CRMC DECISION WORKSHEET

2024-10-023

STATE OF RHODE ISLAND
COASTAL RESOURCES MANAGEMENT COUNCIL
 STAFF REPORT TO THE COUNCIL

| Applicant's Name: | Wickford Olde Theatre LLC |

Above: Portion of submitted plan set showing the proposed layout

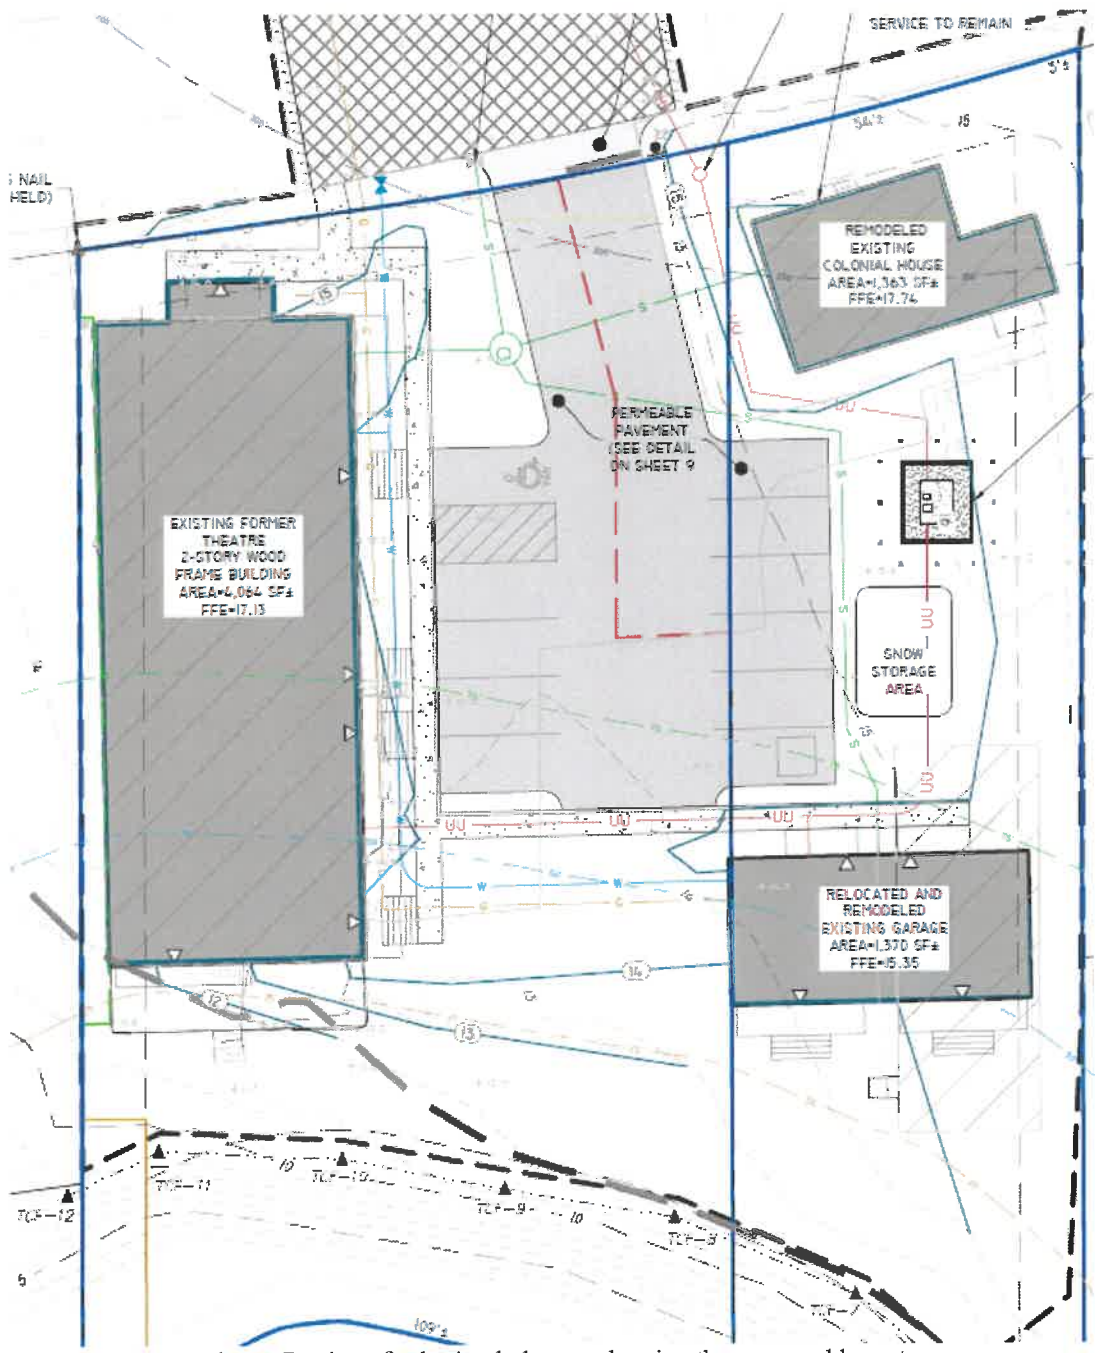
The proposal is for 18 condominium units with 10 parking spaces. According to the application narrative, some of the parking necessary to support the residences on site shall be located off site to the north within the larger property of the Wickford School (approved by CRMC in October 2025). Concrete sidewalks shall be established to grant access to the theater and garage buildings.

Above: Portion of existing layout plan and portion of proposed layout plan with Coastal Feature highlighted in Blue and Setback highlighted in yellow (not to scale, for illustrative purposes)

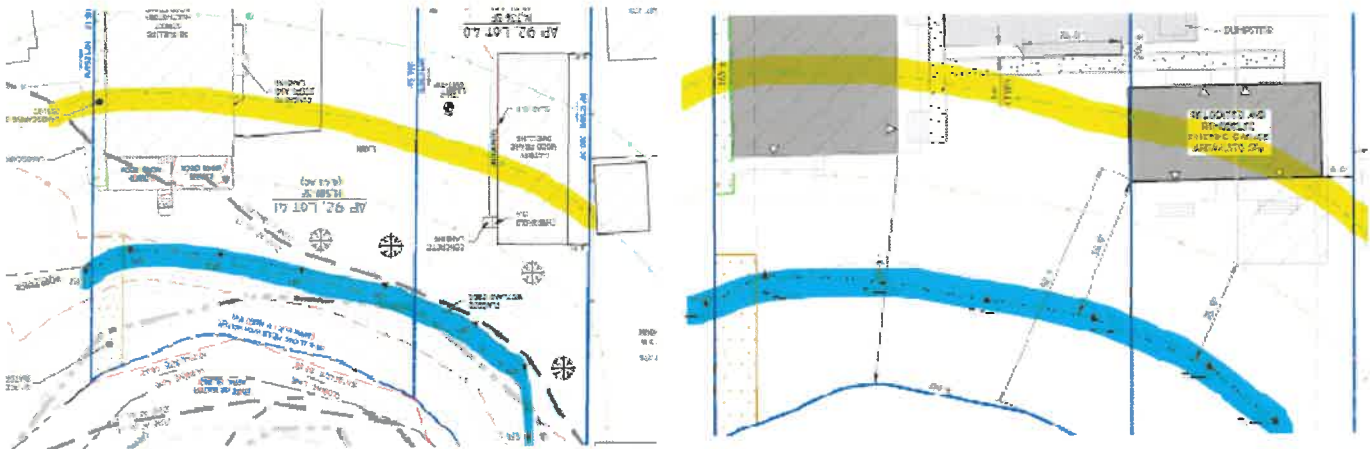
As currently situated, both the garage and the olde theater building do not meet the minimum 50' setback required. The olde theater building is proposed to remain in its current location, and the garage structure will be rotated 90 degrees. Unlike the proposal within the Preliminary Determination, the garage structure will not change in footprint. Rotating the garage structure will slightly reduce the area of structure within the Setback, as shown below:

The applicant has submitted a Variance Request which addresses the Setback associated with the relocated garage building.

Above: Portion of PD proposed layout and portion of landscape plan depicting proposed plantings & variable width. (not to scale, for illustrative purposes)

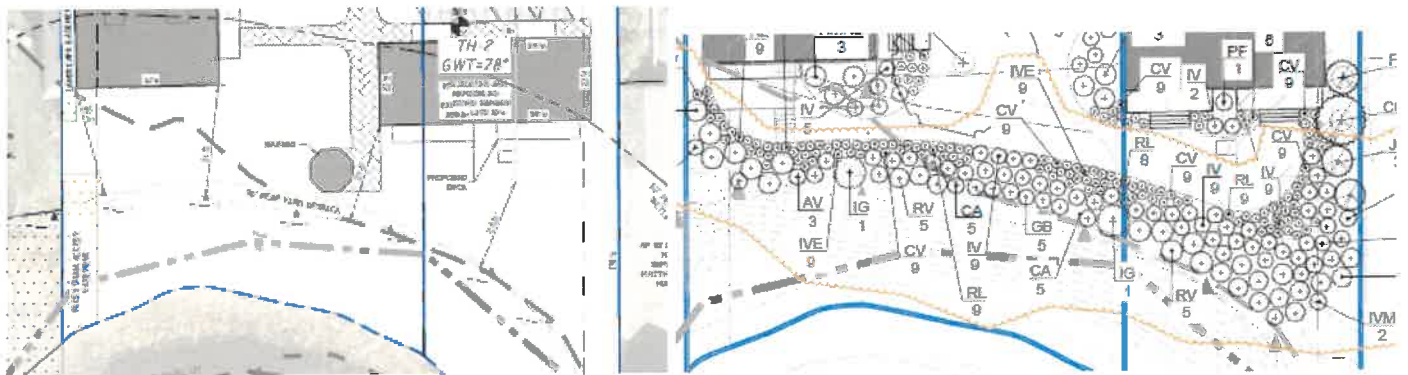
While this project on its own does not require the implementation of a Coastal Buffer Zone, the guidance for commercial development combined with the Agency’s commitment to protecting Type 1 shorelines, resulted in staff recommending a Buffer Zone in the initial PD and again after submission of this application. Utilizing Table 4, a standard Buffer Zone would be 75 feet (the combined lot size is 27250ft² on Type 1 Water).

The 2022 Preliminary Determination requested that a Buffer Zone be implemented along the shore as none was proposed at that time, and the layout increased the Setback Variance beyond what was currently on site with existing development. At application submission, the garage structure had been altered and the proposed gazebo removed, but still no Buffer Zone was proposed. Staff questioned this, revised plan was received on March 31. The Buffer Zone proposed is less than the guidance 75 feet due to the location of the two existing buildings on site. Currently there is little to no Buffer Zone on site, and a variable width Buffer will be densely planted with Native Species. Staff requested that the applicant add three evergreen trees to replace those being removed. At the time of this writing, there has been no response, and staff would recommend Council stipulate this planting.

Three native evergreen trees shall be planted within the Buffer Zone. These trees shall be eastern red cedar or Atlantic white cedar or similar. Staff shall be notified of the native evergreen trees chosen prior to issuance of this Assent.
